SUBJECT: PIER 4 PHASE 2 RECONFIGURATION
PROJECT NO. 091251
CONTRACT NO. 070136

ADDENDUM NUMBER TWO

A. DRAWING E8.2 CONDUIT AND CONDUCTOR SCHEDULE

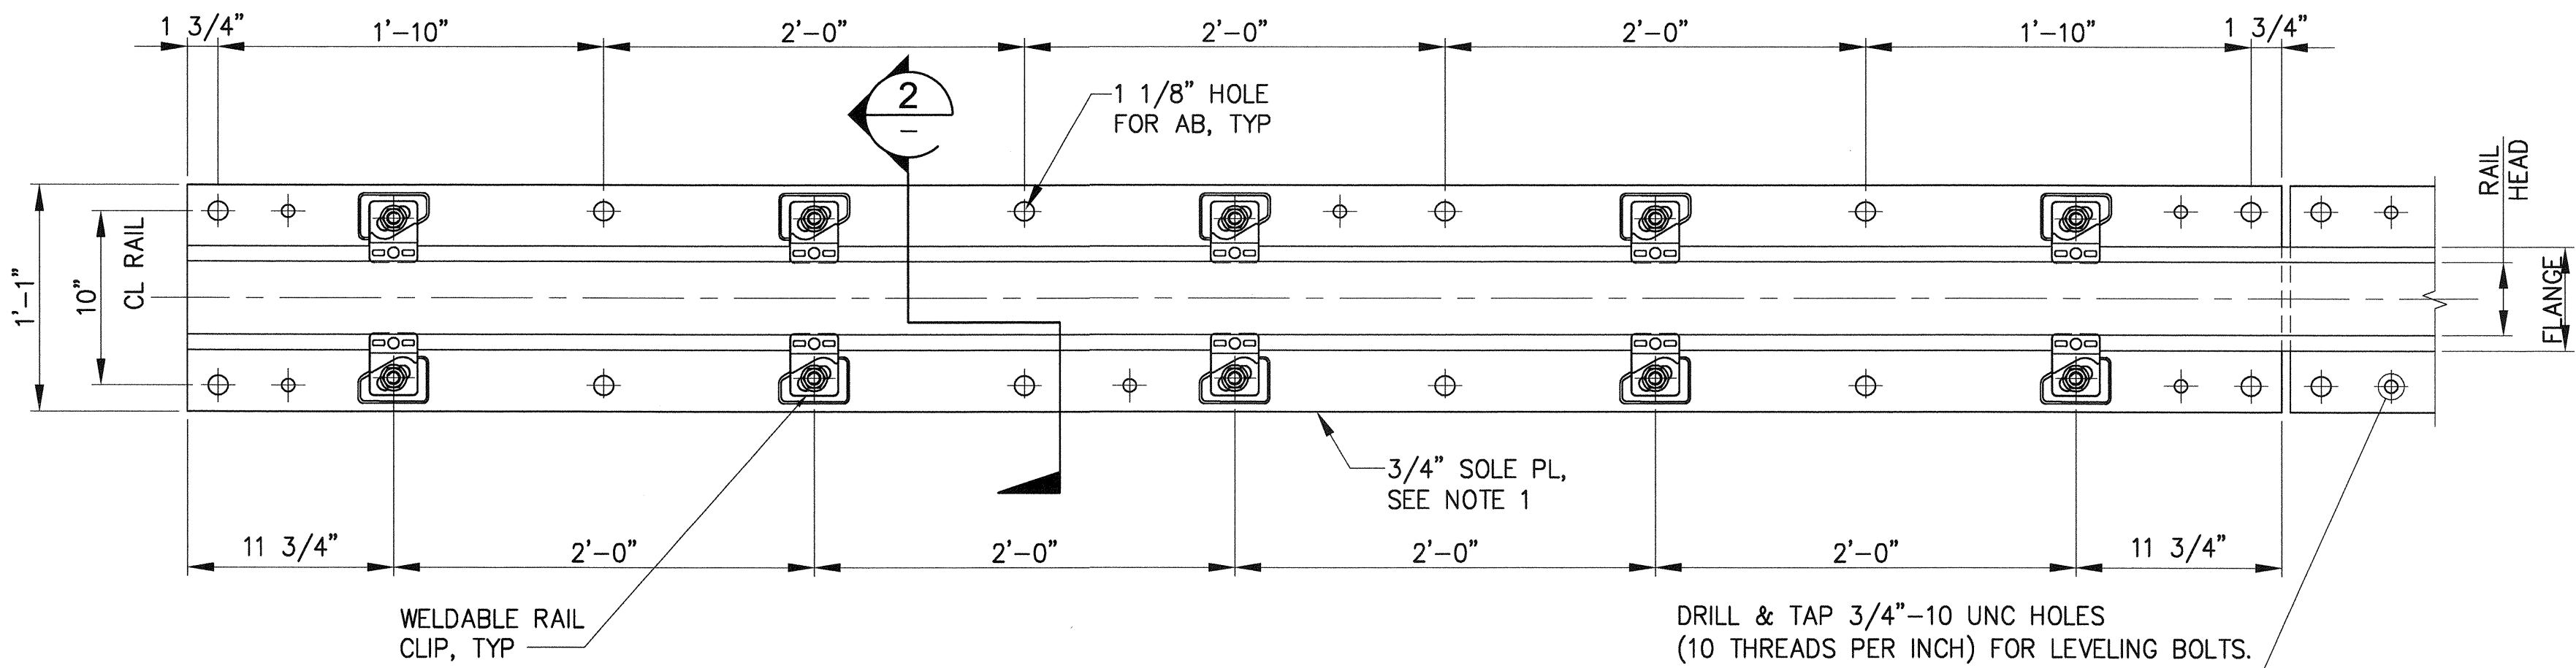
1. **REVISE** Conduit and Conductor Schedule as denoted. (See revised Drawing E8.2 attached)

**SECTION -
SOFT MOUNT RAIL**
S15.1, S15.2, S40.2
3"=1'-0"

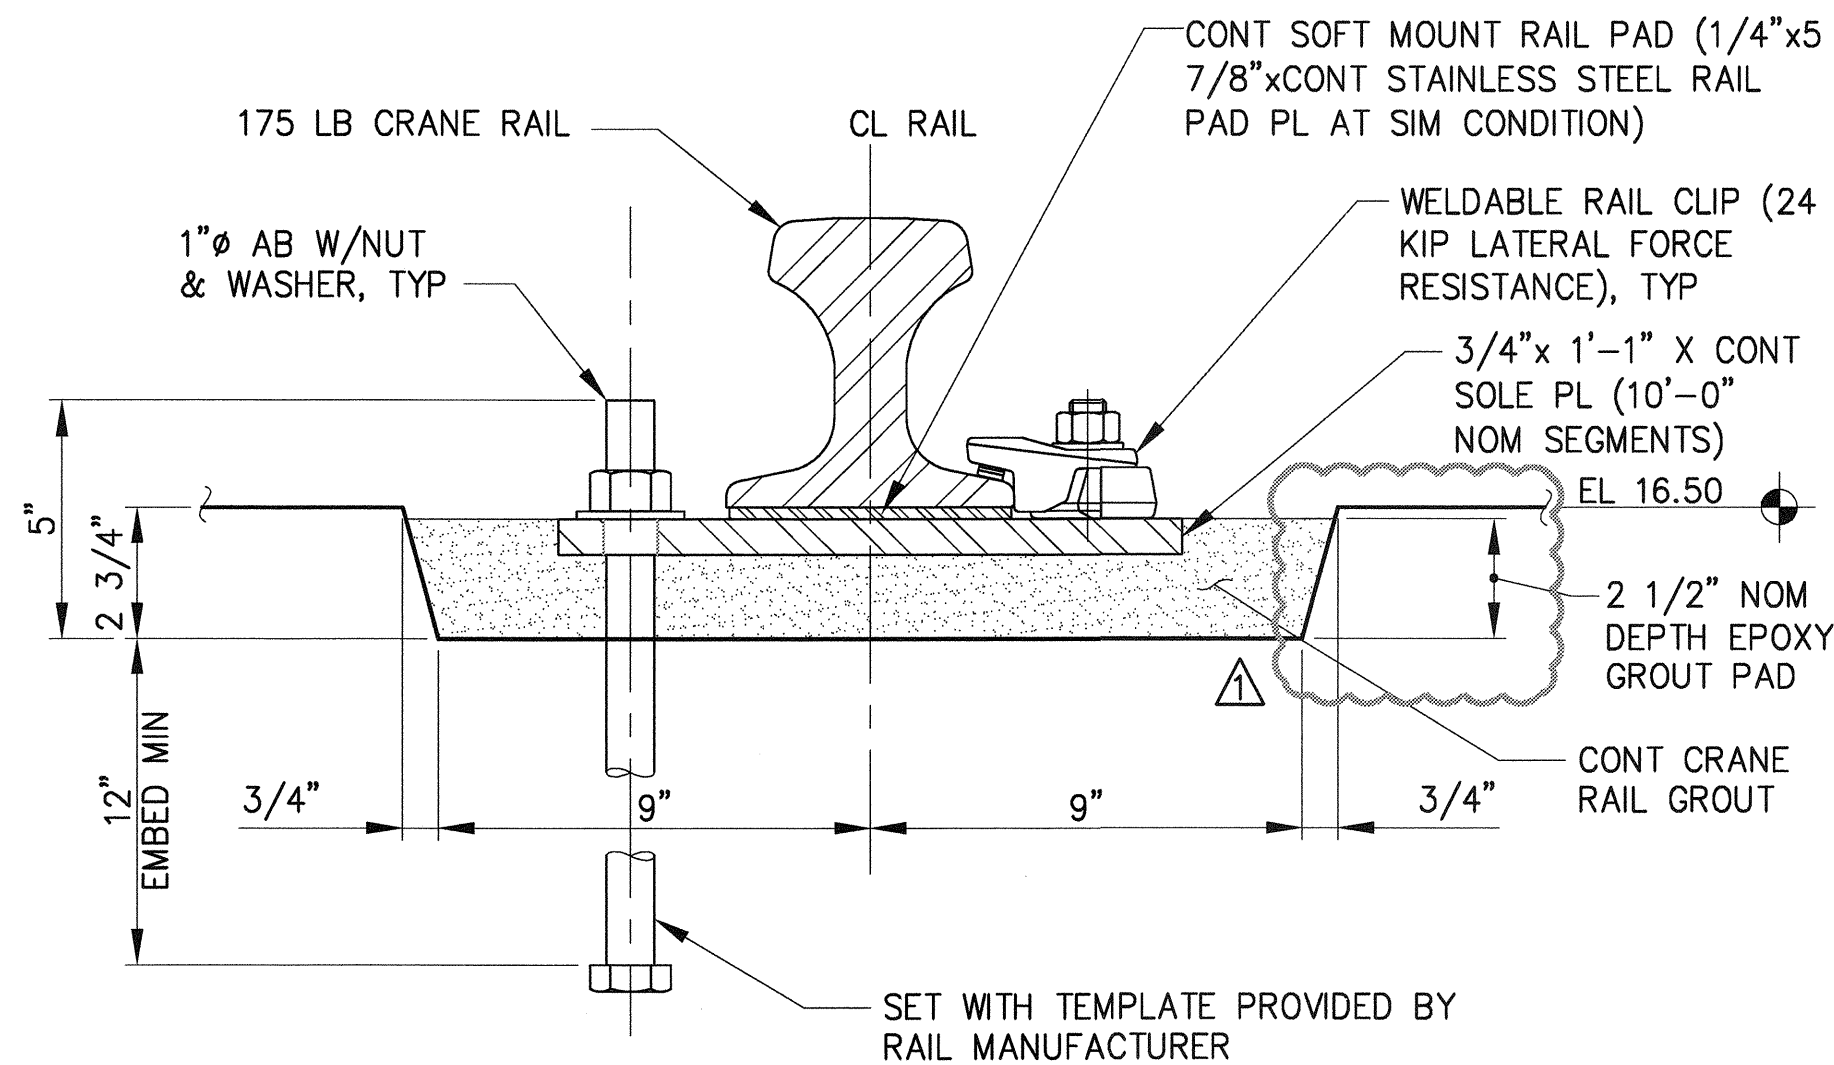
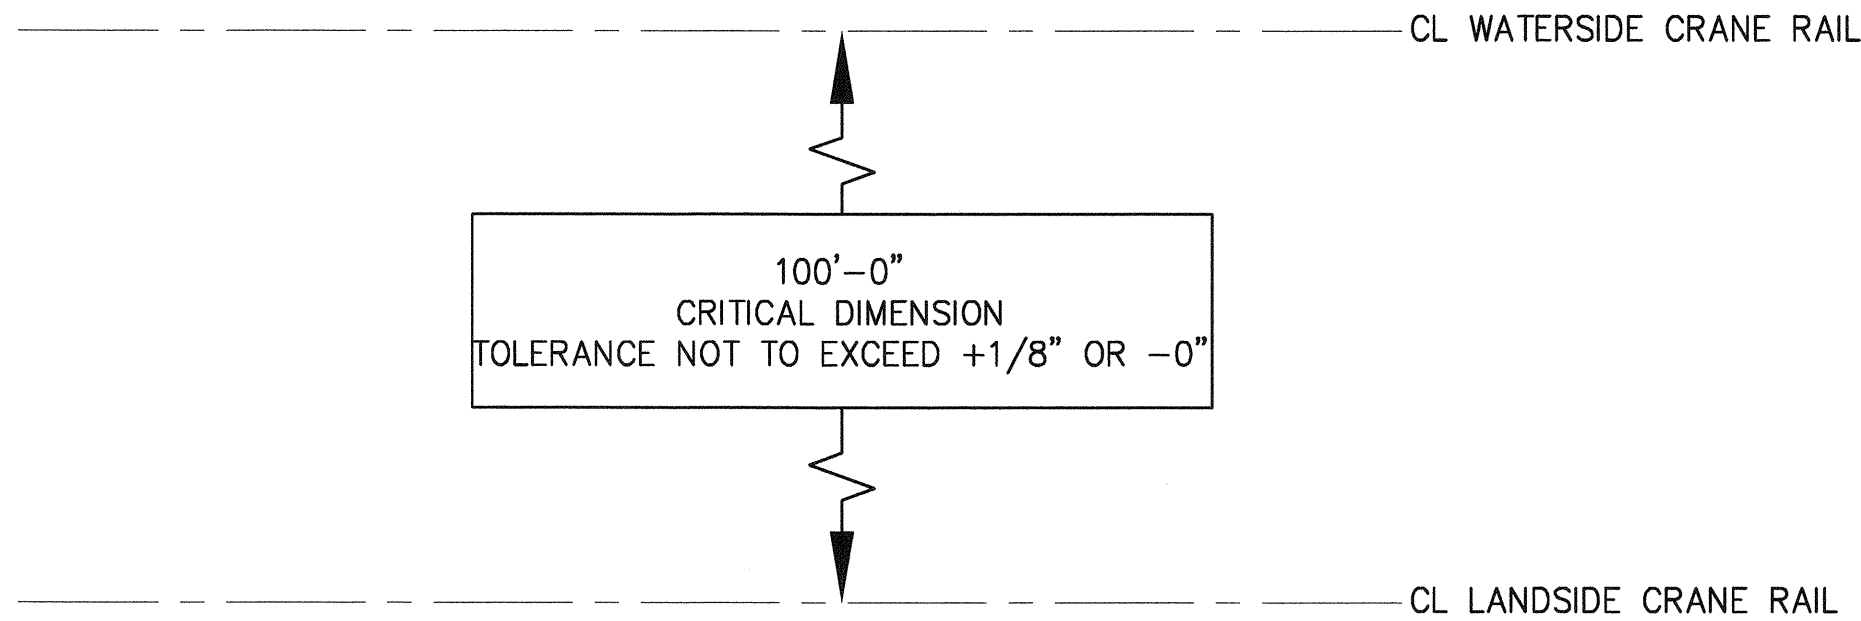
1. **REVISE** Detail 2 – Section – Soft Mount Rail (See revised Drawing S40.1 attached.)
